PERMIT

P 514634-A

SEWAGE DISPOSAL SYSTEM
HOWARD COUNTY HEALTH DEPARTMENT
BUREAU OF ENVIRONMENTAL HEALTH
410-313-2640

REPAIR

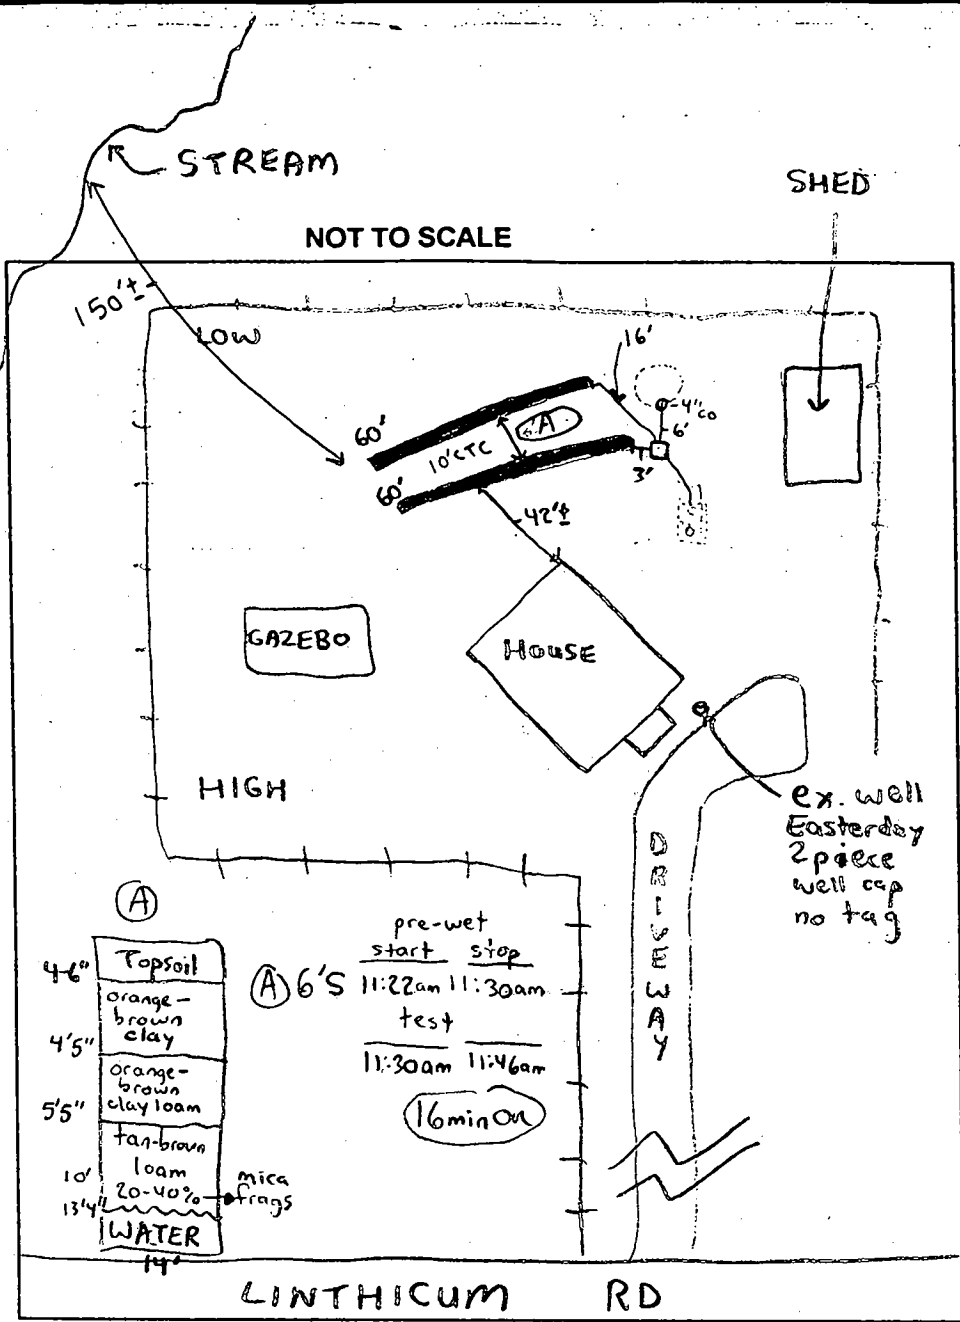
PRE-CONSTRUCTION INSPECTION: 12/4/00 - HOLE DUG IN LOCATION (A) SEE PROFILE & TEST
 INSTALL SYSTEM AS SPECIFIED ON FRONT OF PERMIT (SR#)

INSPECTION COMMENTS: OK TO COVER ALL WORK, LIMITED AREA EXISTS FOR
 FUTURE REPAIRS (SR#)

Install D.Box off of ex. septic tank. Run 2-60' trenches off of D.Box but also have D.Box serve ex. drywell (allowing for drywell to take water but not as much as trenches) (Use levelers) Keep trenches 10' Center to Center to conserve future repairs, keep trench 100' away from ex. well.
